PETITION NO: Z-5
HEARING DATE (PC): 02-07-17
HEARING DATE (BOC): 02-21-17
PRESENT ZONING: R-20 with Stipulations
PROPOSED ZONING: R-20 with Stipulations

PROPOSED USE: Amending the Cemetery
Preservation Stipulations
SIZE OF TRACT: 0.4594 acres
DISTRICT: 1
LAND LOT(S): 166
PARCEL(S): 56
TAXES: PAID X **DUE** _____
COMMISSION DISTRICT: 2

ZONING COMMENTS:

Z-5 JOSHUA POWELL, SR. AND LAUREN POWELL

Z-5 photo from cemetery side #2

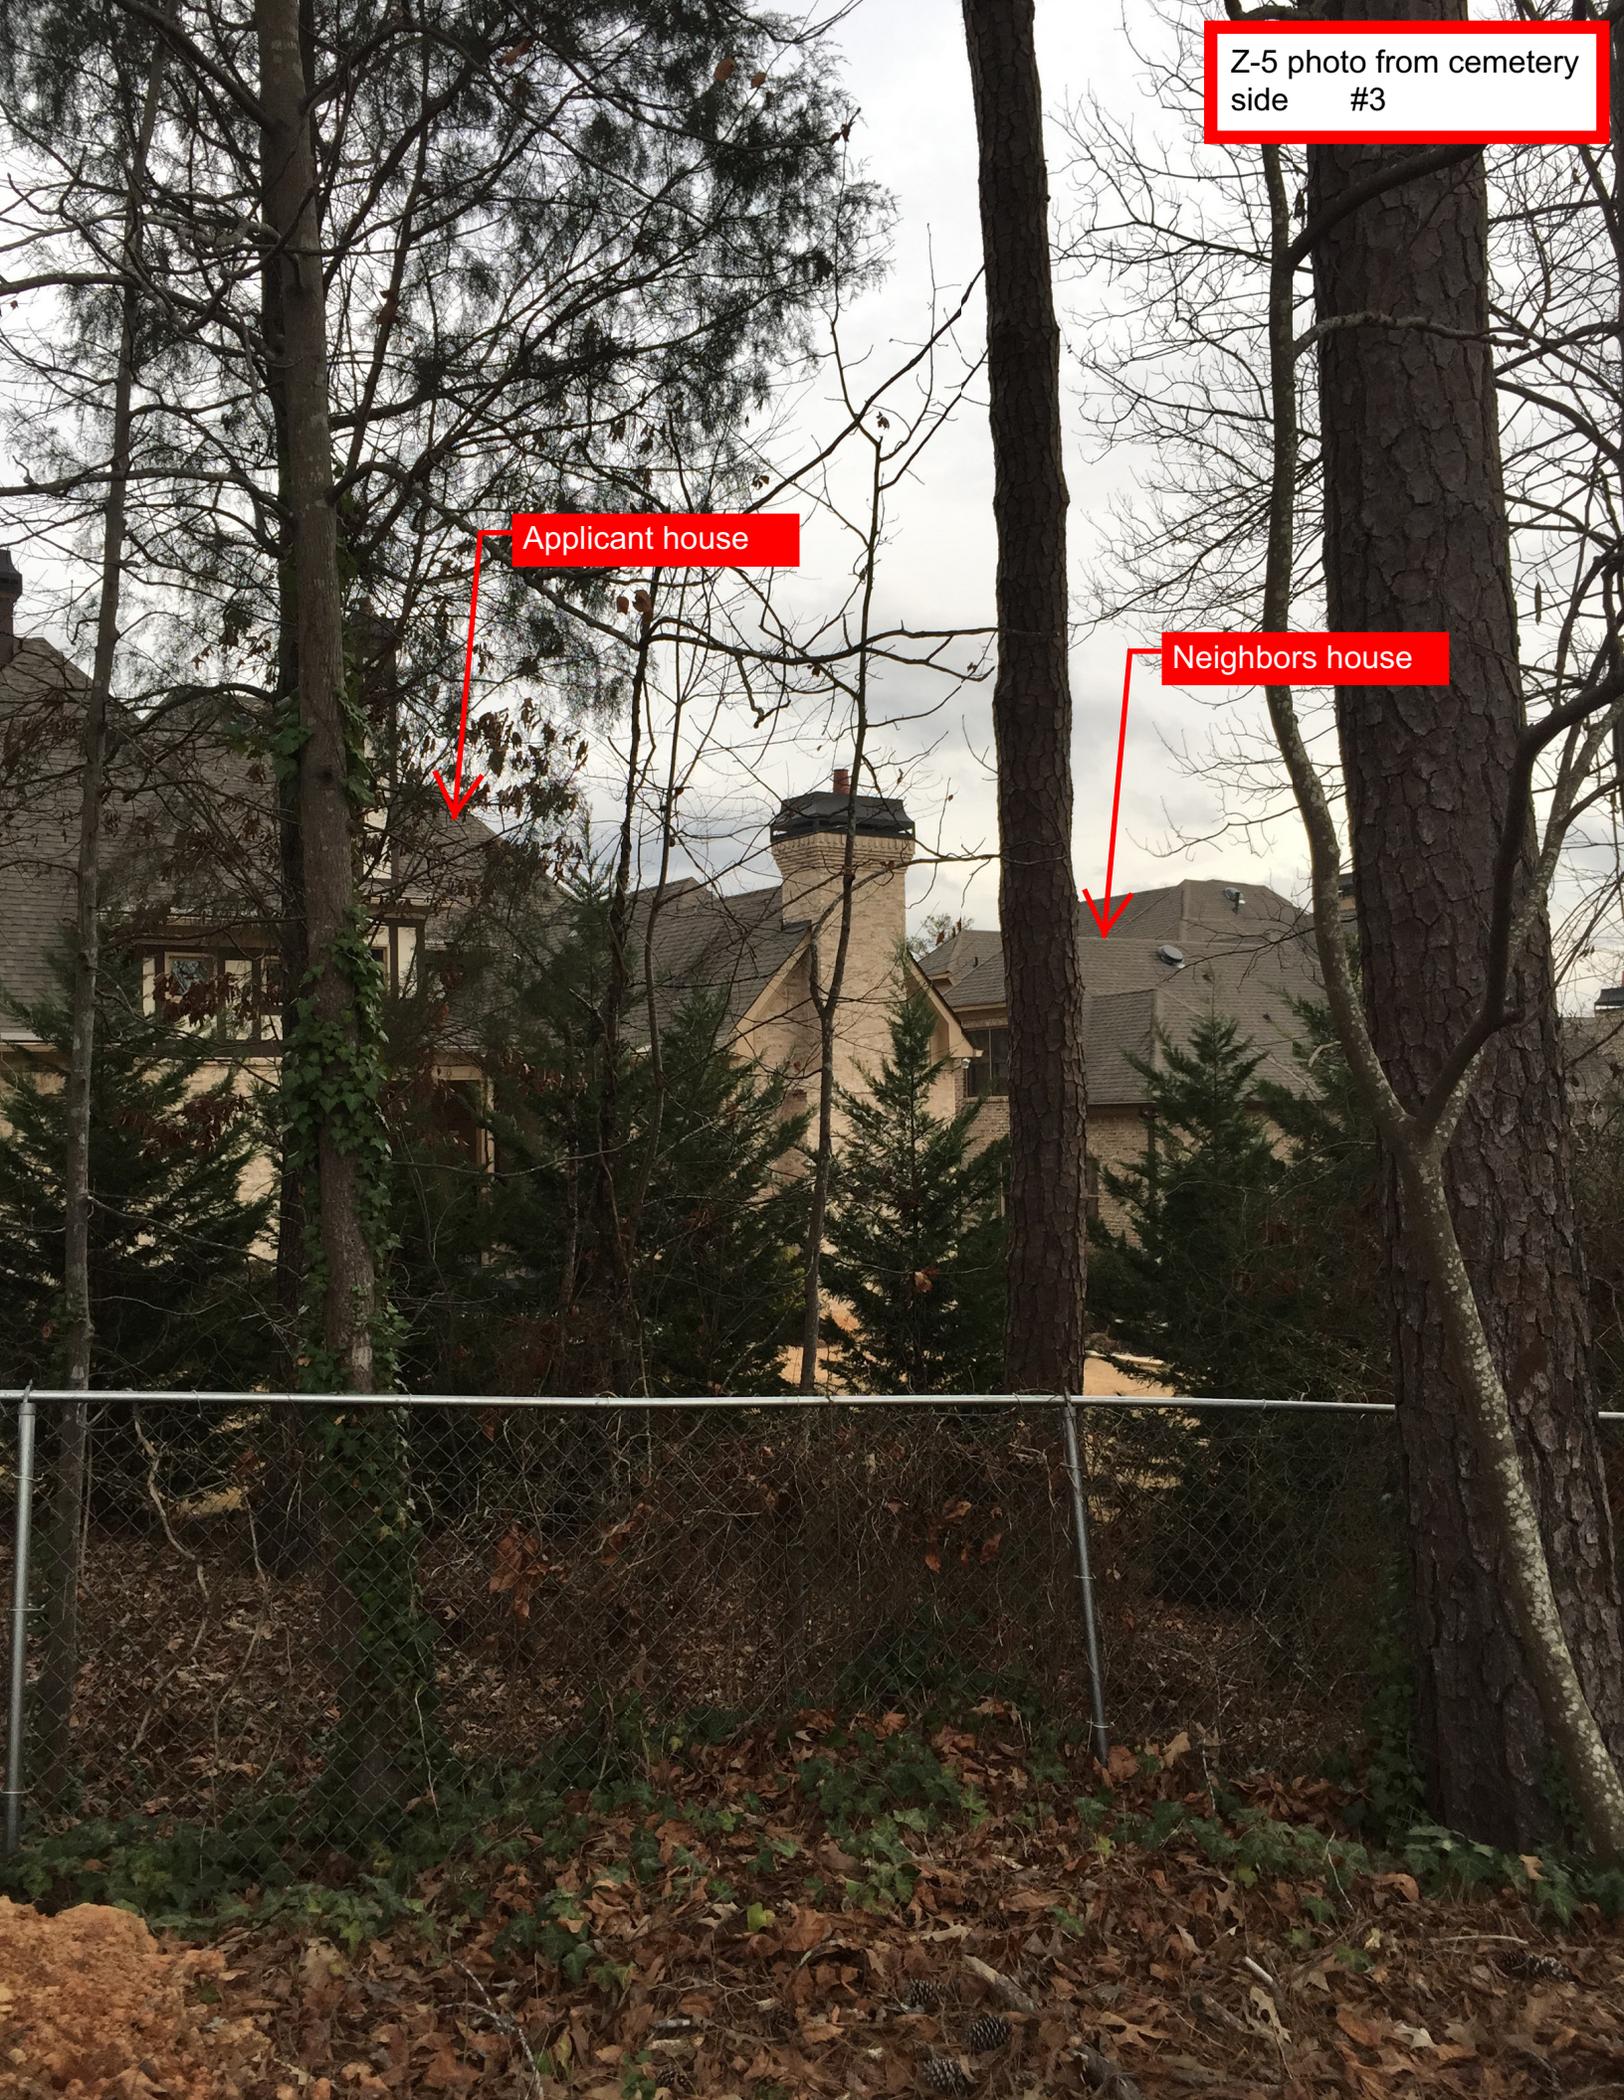
- A. It is Staff's opinion that the applicant's rezoning proposal may permit a use that is not suitable in view of the use and development of adjacent and nearby properties. The property's original rezoning stipulated a 50-foot cemetery buffer in order to properly protect the adjacent cemetery. Staff has not been supportive of completely waiving the required cemetery buffer for the last two rezoning cases for this property.

- B. It is Staff's opinion that the applicant's rezoning proposal may have an adverse effect on the usability of adjacent or nearby property. Staff is not supportive of reducing the buffer completely. However, the 50' cemetery buffer comes up along the rear line of the back of the house. Staff would be supportive of reducing the cemetery buffer to 25' for this lot after visiting the site. This would allow the applicant to have a small backyard to enjoy and would allow a cemetery buffer that could provide a visual and noise screen between the uses.

- E. It is Staff's opinion that there are existing and changing conditions affecting the use and development of the property which give supporting grounds for approving the applicant's rezoning proposal for a 25' reduction in the cemetery buffer. After an onsite visit, Staff believes a 25' landscape and natural buffer would provide protection for the cemetery. At the onsite visit, Staff did note that the applicant's house sits lower than the cemetery and the applicant has a row of leland cypress trees that already provide for visual screening between the uses (see attached photos). Staff does believe more landscaping would have to be added in certain areas to improve screening which would have to be approved by the county arborist.

1. Cemetery buffer be reduced to 25'.
2. Applicant submit a landscape plan to the County Arborist within 30 days of the final rezoning decision.
3. Applicant to have the 25' cemetery buffer planted within 60 days of the final rezoning decision.
4. Allowance to keep retaining wall in its current location and size.
5. All previous stipulations not in conflict.
